# LOP STAKEHOLDER ADVISORY COMMITTEE MEETING

Thursday, February 21, 2008

The following table contains the comments and key issues relating to the Lake Ontario Park Master Plan as raised by the Stakeholder Advisory Committee in the Task Group Meetings held on December 4, 5 and 6 of 2007. At the upcoming Stakeholder Advisory Committee on February 21, 2008, the Lake Ontario Park Master Planning Team will make a presentation of these issues and the proposed responses to each issue. Some of the issues refer to numbered images that follow the table.

## THE BASE LANDS draft masterplan

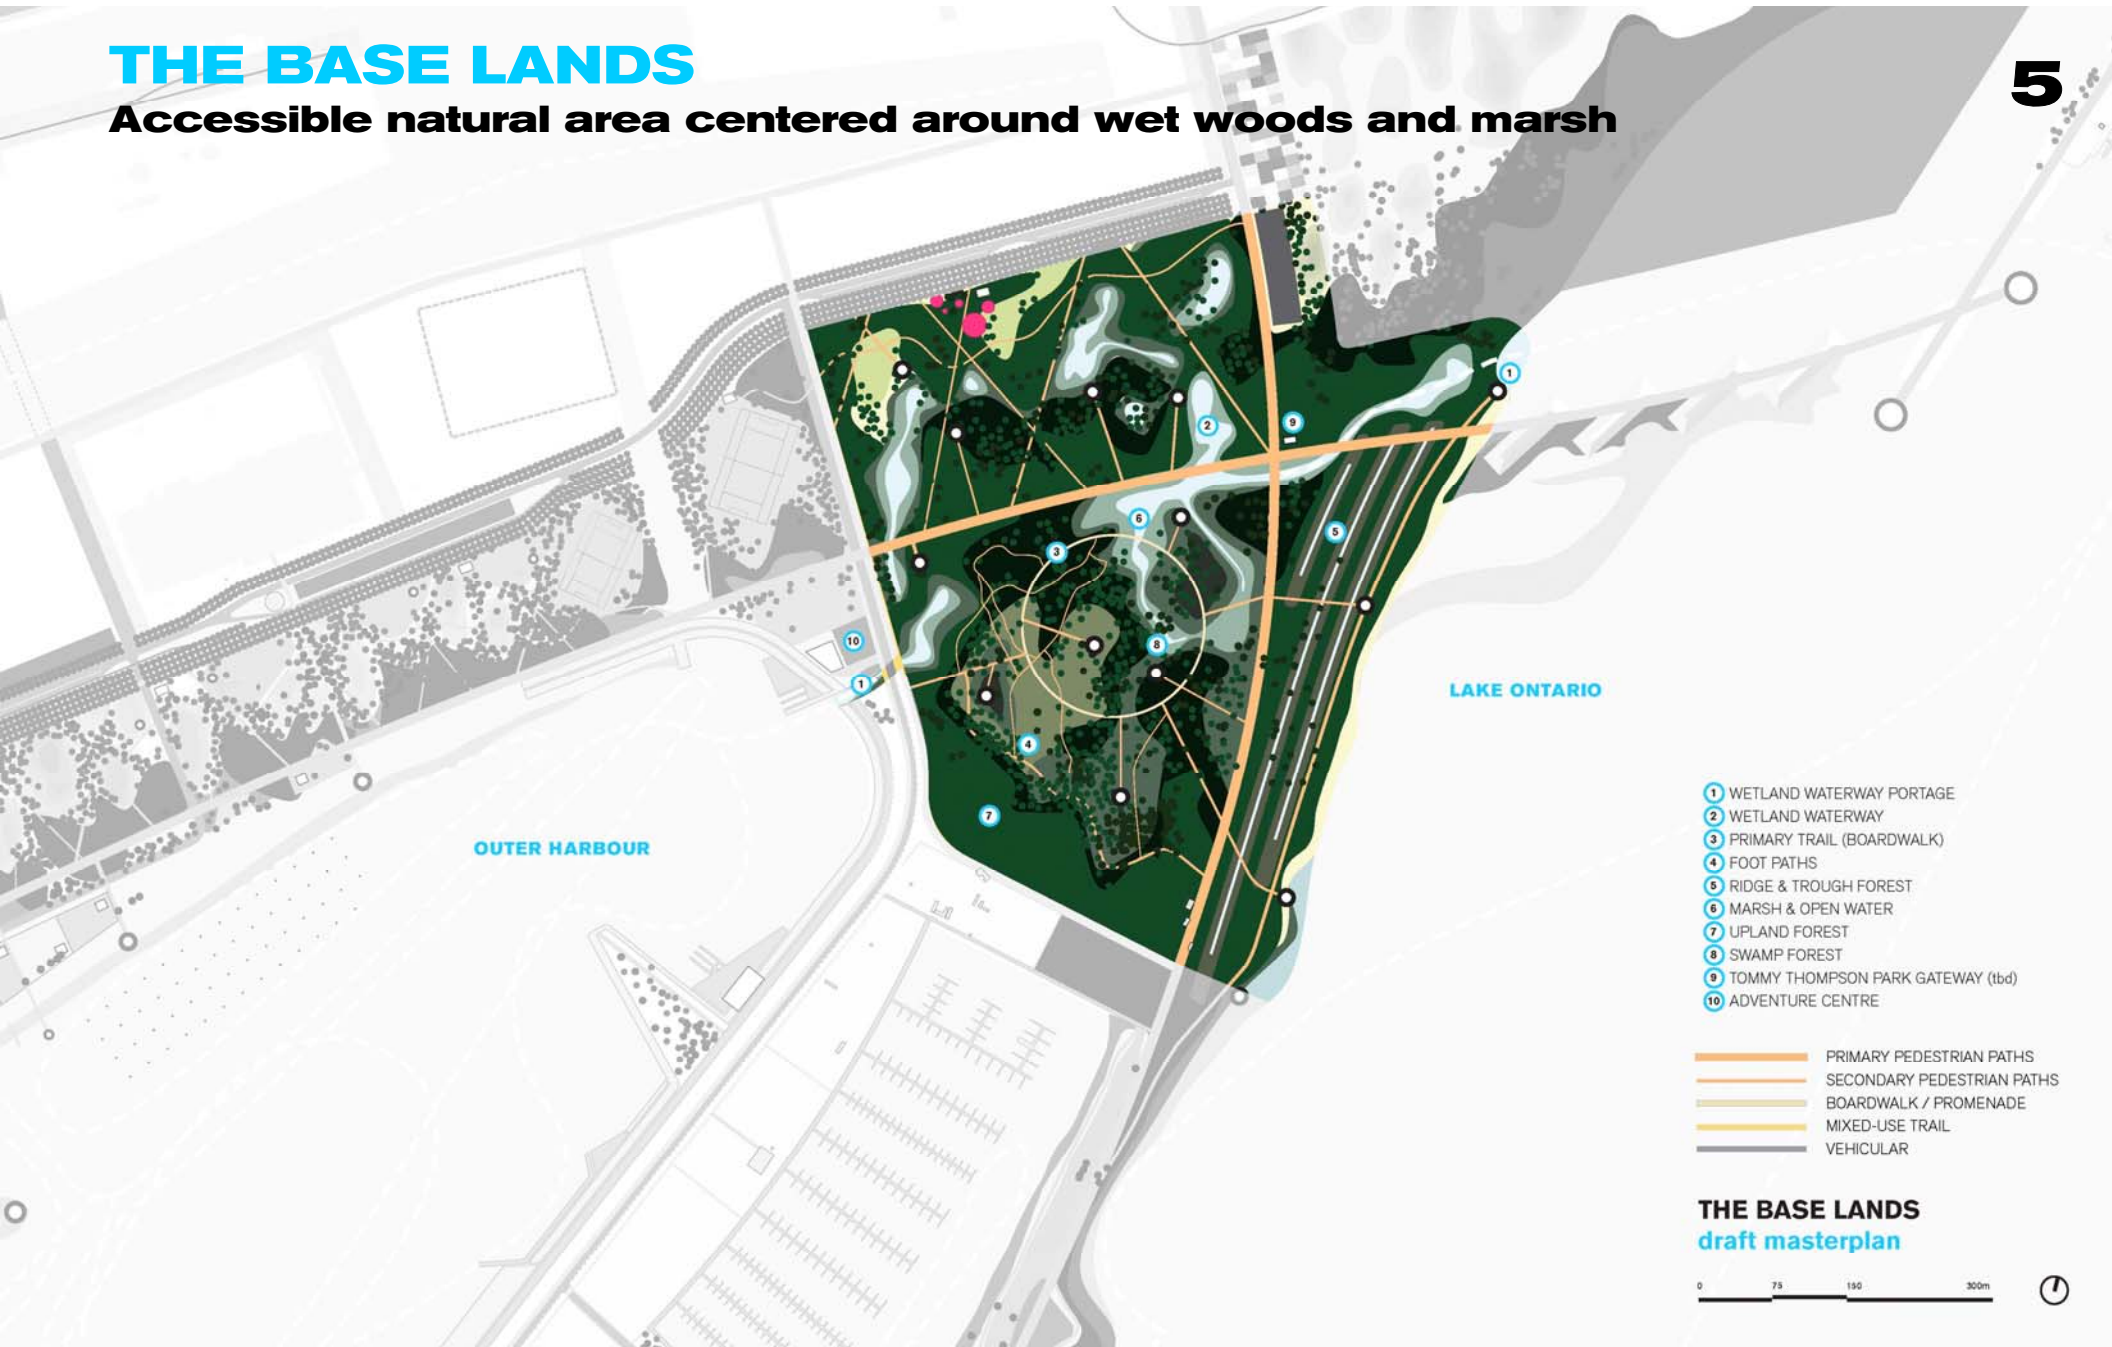
<b>THE BASE LANDS (COMMENTS FROM DECEMBER 6, 2007)</b>		
<b>ISSUE</b>	<b>MEETING DISCUSSION</b>	<b>PROPOSED MP RESPONSE</b>
<b>Adventure Centre</b>	<ul style="list-style-type: none"> <li>• It was suggested that the purpose and function of the Adventure Centre needs to be better defined, and that the number of functions seem somewhat contradictory to its scale.</li> <li>• In discussing the location, a number of rationales were put forward. These include: <ul style="list-style-type: none"> <li>• It is near the Bar transect;</li> <li>• It is near a point of vehicular access (Marina Drive);</li> <li>• It has frontage on the Outer Harbour;</li> <li>• It is a central location in the Park;</li> <li>• It is close to the outdoor educational opportunities of the Base Lands and Spit;</li> <li>• The eastern end of the Outer Harbour is sheltered, relatively unused, and is away from the sailing clubs, therefore good for canoeing and kayaking.</li> </ul> </li> <li>• Disadvantages of the proposed location include: <ul style="list-style-type: none"> <li>• Potential conflict with the multi-hulls on their moorings.</li> </ul> </li> <li>• The Design Team noted that the Adventure Centre was inspired by similar centres in New Brunswick, developed as part of the Tourist Strategy for the Provincial Parks in St. George and St. Andrew.</li> <li>• Parks staff indicated that they support the idea of the Adventure Centre but need to meet with TRCA and others to flesh out the proposal.</li> <li>• An interpretive centre in Lock Levin, Scotland was cited as a good example of how birdwatching opportunities can be provided at an interpretive centre.</li> <li>• It was noted that the Portlands Energy Centre will have an adverse visual impact on the area.</li> <li>• It was suggested that the LOP Master Plan should describe the process of what needs to happen to move the Adventure Centre proposal forward.</li> </ul>	<p>PFR staff held an internal workshop on the Adventure Centre (representatives of WT and the Design team were in attendance). PFR is in support of the location for the Adventure Centre as identified in the Master Plan. Several objectives for the Adventure Centre were identified:</p> <p>The 'Adventure Centre' is envisioned as a centrally located, 12-month facility that offers the following resources to park visitors:</p> <ol style="list-style-type: none"> <li>1. Multi-purpose community rooms and meeting spaces;</li> <li>2. Programming focus for PFR daycamps (especially eco-camps);</li> <li>3. Innovative recreational programming that incorporates education with active play;</li> <li>4. Orientation point for guided/self-guided exploration of the park;</li> <li>5. Referral to OHSF boat clubs for sailing, rowing, windsurfing instruction;</li> <li>6. Bike rentals;</li> <li>7. Canoe/kayak rentals and instruction, with a focus on boating safety and etiquette;</li> <li>8. Canoe/kayak public storage and launching; and</li> <li>9. Fishing piers and equipment rentals;</li> </ol>

<b>THE BASE LANDS (COMMENTS FROM DECEMBER 6, 2007)</b>		
<b>ISSUE</b>	<b>MEETING DISCUSSION</b>	<b>PROPOSED MP RESPONSE</b>
<b>Boardwalks</b>	<ul style="list-style-type: none"> <li>• It was suggested that the circular shape of the proposed boardwalk in the Base Lands was an arbitrary design, and not in keeping with the wild nature of the area. Trails at grade would be more naturalistic.</li> <li>• In response to a question about the ability to use mown trails, the Design Team indicated that this may be appropriate for some trails in the Base Lands.</li> <li>• The Design Team noted that the primary role of the boardwalk, whether elevated or not, is to function as a mechanism for controlling and organizing access to the Base Lands. Without direction as to how to access the site, people will create their own trails. A planned trail network can also help keep people away from sensitive areas. The Design Team noted that this is especially important in the context of increased future development.</li> <li>• The Design Team agreed that it is possible to build the trail network over time as usage increases. This would mirror the evolution of the landscape over time. Trails could be based on existing trails.</li> <li>• It was suggested that the Master Plan document include the principles of developing both habitat and the trail system over time in a gradual process.</li> </ul>	<p>The Design Team has revised the form and character of the trails within the Base Lands, by tracing existing foot paths and representing the widths of the trails more accurately (Ref. image 5 and image 9).</p> <p>As stated above an objective of the Base Lands makes clear reference to the need for sensitive, strategic implementation of new trails and pathways:</p> <p>“Promote the slow, delicate introduction of public access trails and the enhancement of habitats by phasing all features over time and in coordination with ecological and stakeholder review”;</p> <p>The Master Plan still maintains the central circular boardwalk (although greatly reduced in width) as a representation of a potential primary route through the Base Lands. The boardwalk is proposed as a means to direct the movement of the general public through a sensitive ecological area, while simultaneously enabling them to walk through and experience the expansive landscape. The Design Team believes strongly that the thin width and large radius of the boardwalk will not compromise the ‘urban wilderness’ experience of the Base Lands.</p> <p>The Master Plan will state that the feasibility, shaping and location of the boardwalk and trails will be determined through further environmental and stakeholder review.</p>
